# TechnologyOne ECM Document Summary

## **TREE REMOVAL APPLICATION - FARAWAY ENTERTAINMENT LIMITED**

## **FARAWAY ENTERTAINMENT LIMITED - RM230775**

Gorge Road Development  
Engineering Design  
Overall Site Layout

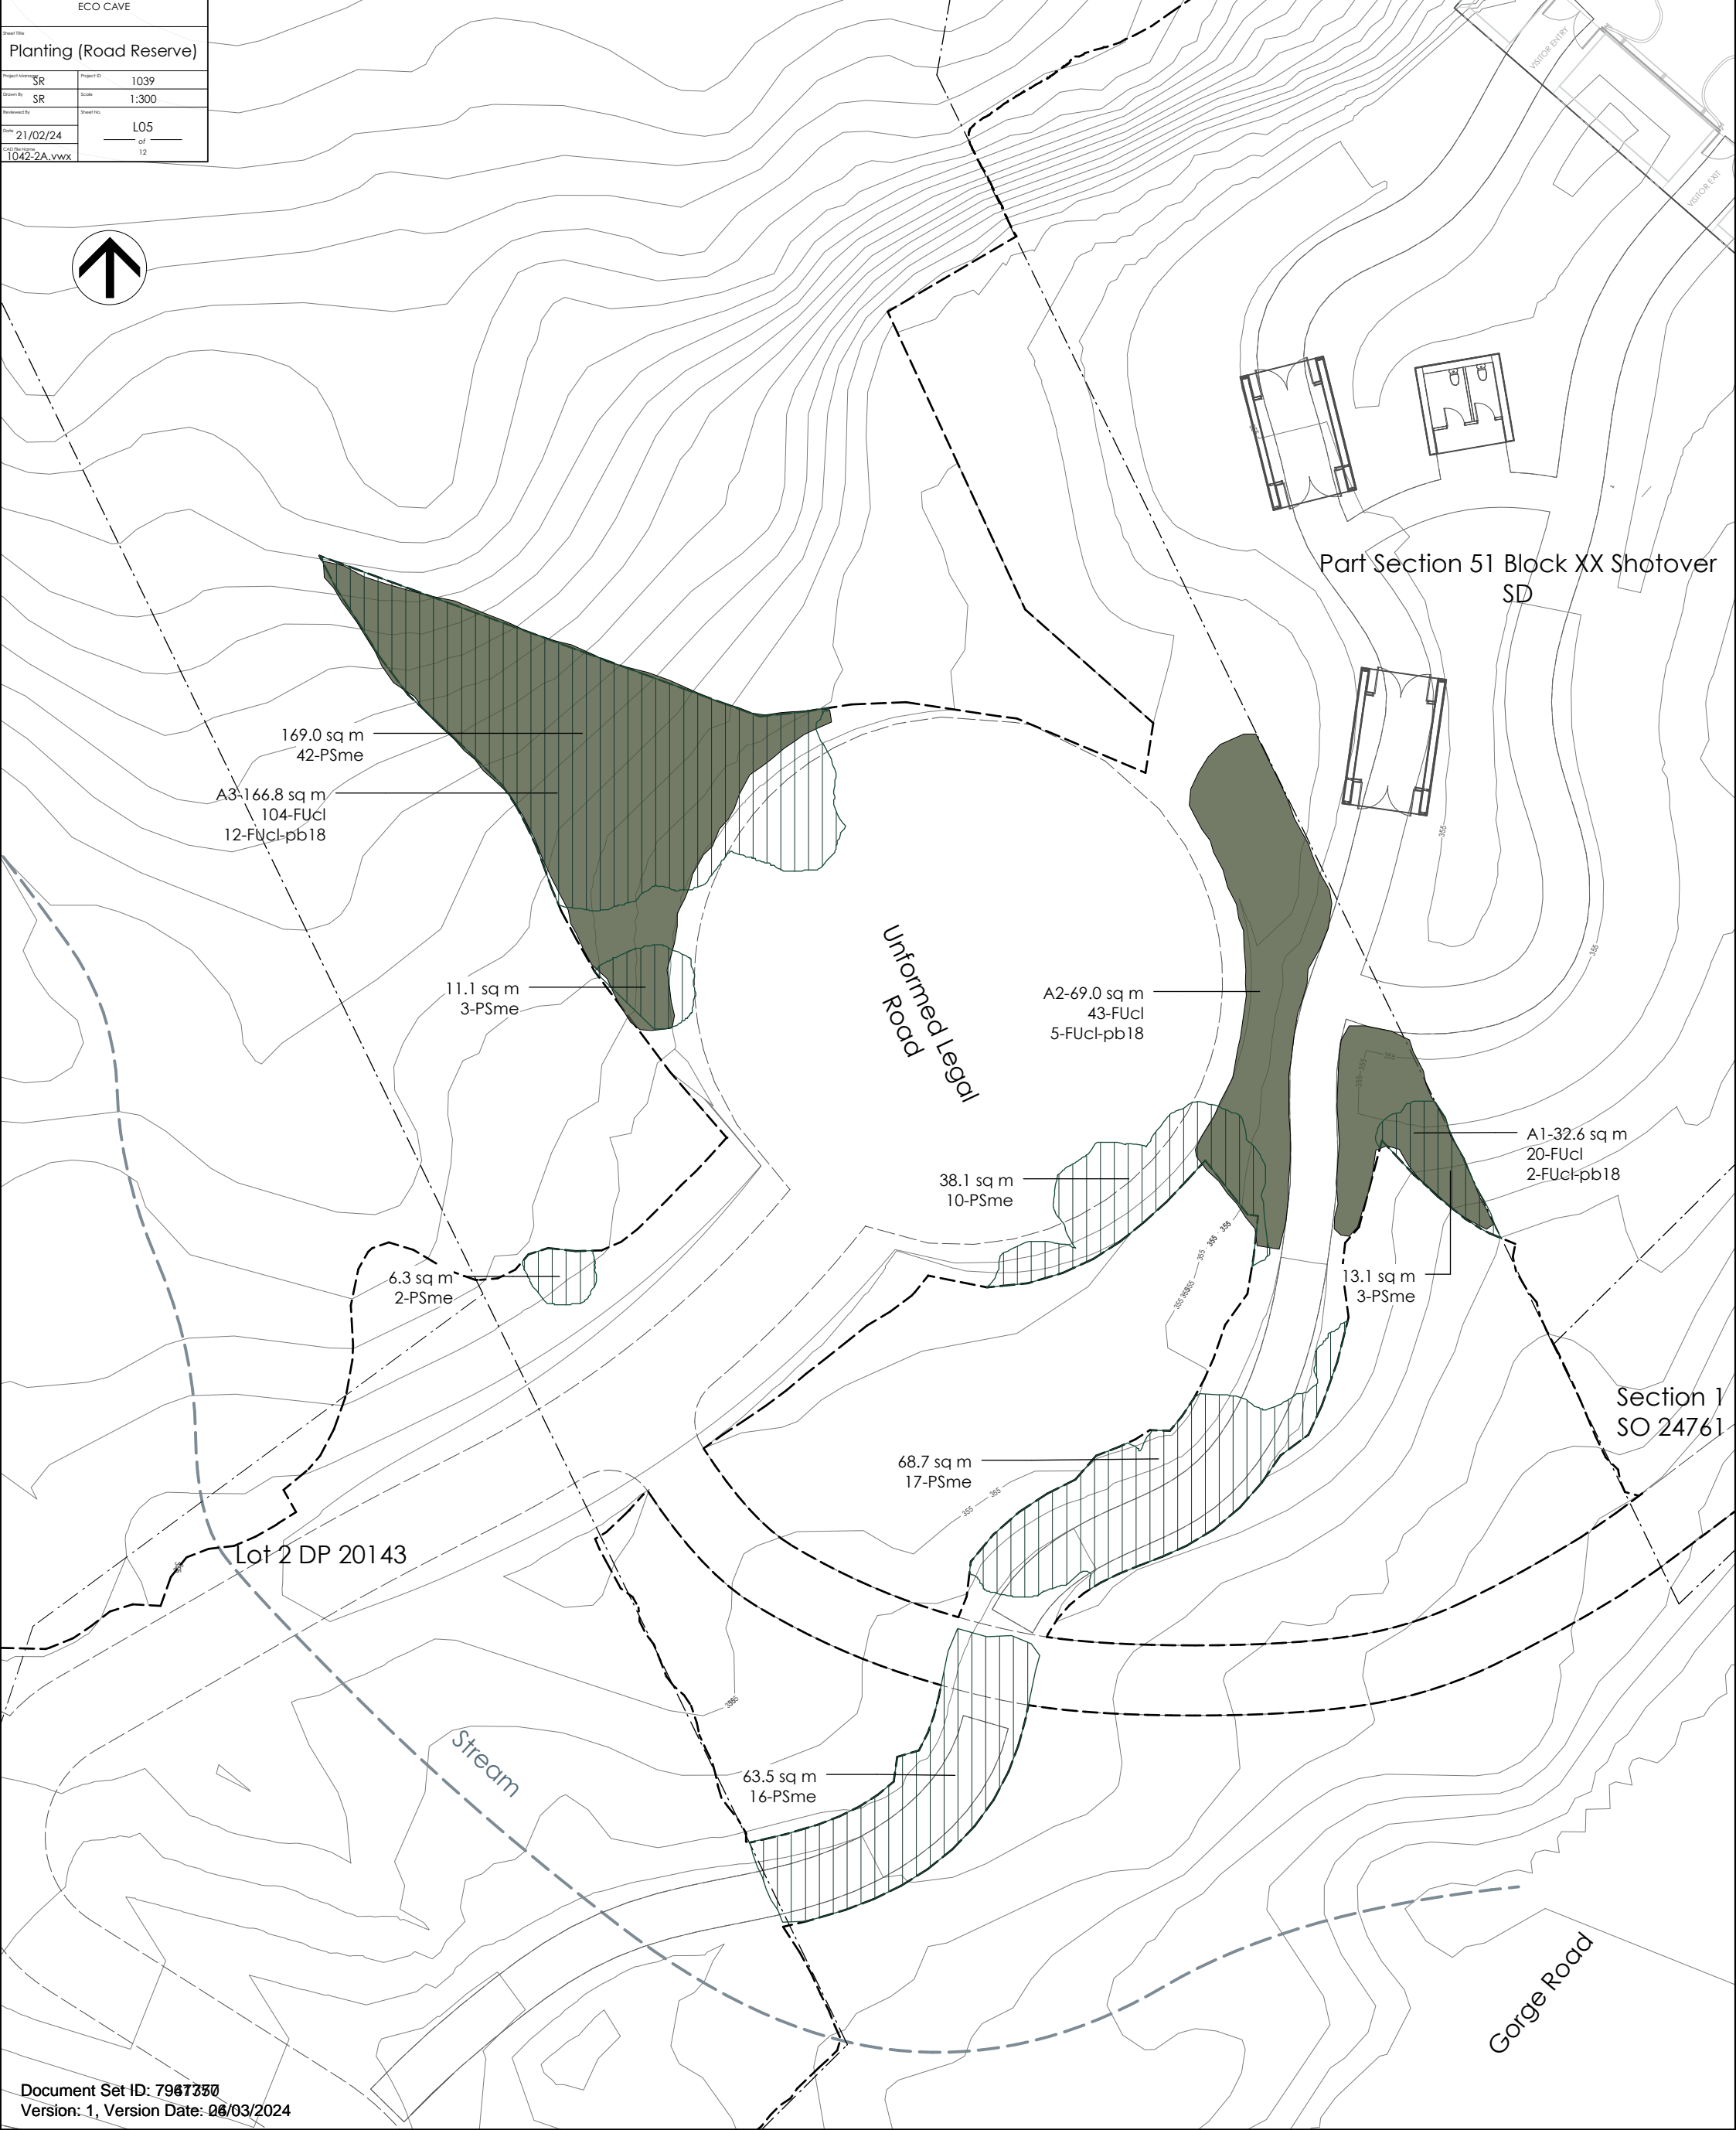
Attached to this letter is a plan that indicates the subject wilding trees to be removed, together with the replacement planting approach. The proposed planting will consist of native species (Mountain Beech).
